CRIME IMPACT STATEMENT

NORMAN ROAD, ROCHDALE
7 no. INDUSTRIAL UNITS (1,927sqm.)

FOR: 1618 Architects
VERSION A: 21/09/2022
REFERENCE: 2022/0372/CIS/01

3.1 Proposed Development

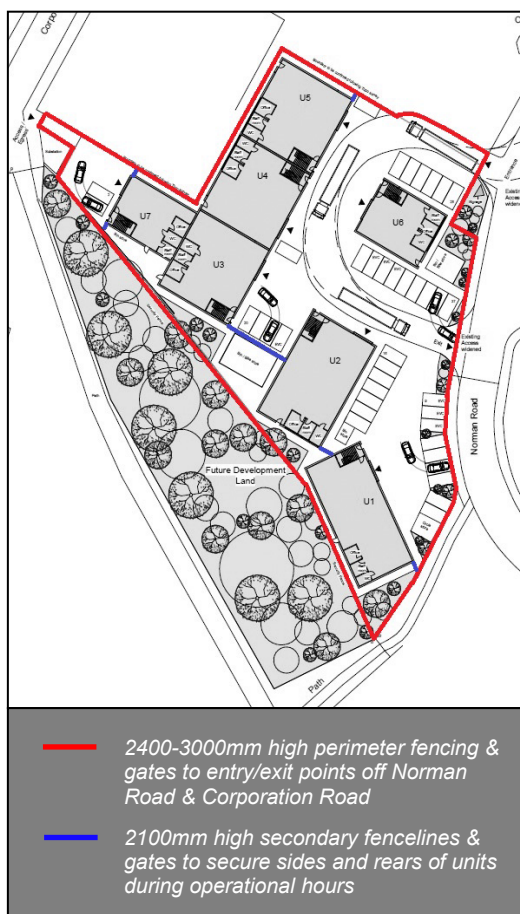
The site is somewhat remote/isolated, where it will benefit from limited levels of activity, footfall/passing vehicular traffic, passive surveillance and direct overlooking - particularly at night. It is surrounded by open space/footpaths to the south and west that could be utilised by offenders to gain access to the site, attack the units and escape without being seen/undetected. As a result, the units could be particularly vulnerable out-of-hours. The whole site, including all of the units and parking/servicing areas, should be enclosed within a 2400-3000mm high robust and secure perimeter fenceline (see illustration opposite and Section 4.6 for more details). The perimeter fencing should be formed by rigid-panel, welded-wire mesh fencing securely fixed to posts with anti-tamper fixings. Care should be taken to ensure that ground level changes do not inadvertently aid climbing or leave gaps underneath fencing panels/gates big enough for someone to crawl through. Any immediately adjacent tree branches along the southern and western perimeter fencing should also be pruned or removed where necessary to ensure they do not form a

climbing aid over the secure boundaries. Secondary fencelines (which could be lower) should be incorporated to prevent unauthorised access to the narrow routes and hidden side/rear elevations of the units at all times of the day and night. The communal cycle and bin stores should also be securely defined/enclosed.

- 3.3.2 The access/egress points to the site (off Norman Road and Corporation Road) must be secured with a 2400-3000mm high vehicle gates to prevent unauthorised access to the site and mis-use of the parking/service areas (see above for illustration and Sections 4.5/4.6 for more information). Given the site will include numerous units and multiple users (and could therefore provide the opportunity for offenders to gain access to the site anonymously, without being challenged), consideration should be given to the gates being automatically operated at all times, in order to prevent unauthorised access during operational hours as well as at night/when closed. Any such gates should be operated on access and egress by staff key fob/proximity reader or via a video access control system linked to each unit – ensuring that visitors are vetted before being allowed access. If the gates must be left open during operational hours, they should at least be secured and operated via access controls if staff access is required outside of normal working hours (e.g. 6pm-7am). Manual gates securing such a large site with multiple users are unlikely to be utilised effectively.
